Product Change Notice (PCN)

PCN Number: **PCN-0210051R**

Product(s) Affected: **NSIM-2-C**

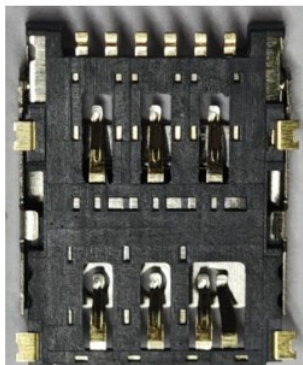
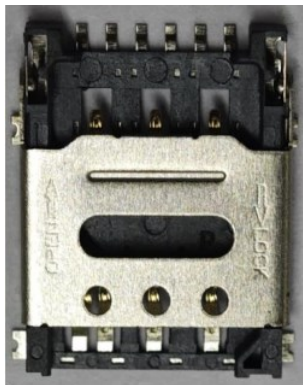
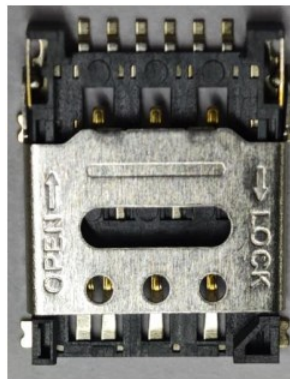
Reason(s) for Change: *Modified design. Production mold is reaching the end of its life and now a new mold is being phased in to replace it.*

- Description of Change: *New production mold being phased in. The ejector pins on the underside are less exposed. Cosmetic improvements to hinged gate.*

Product Availability: *Any production orders marked January 21, 2025, or later will have the new design implemented. Last time buys are available until January 14, 2025*
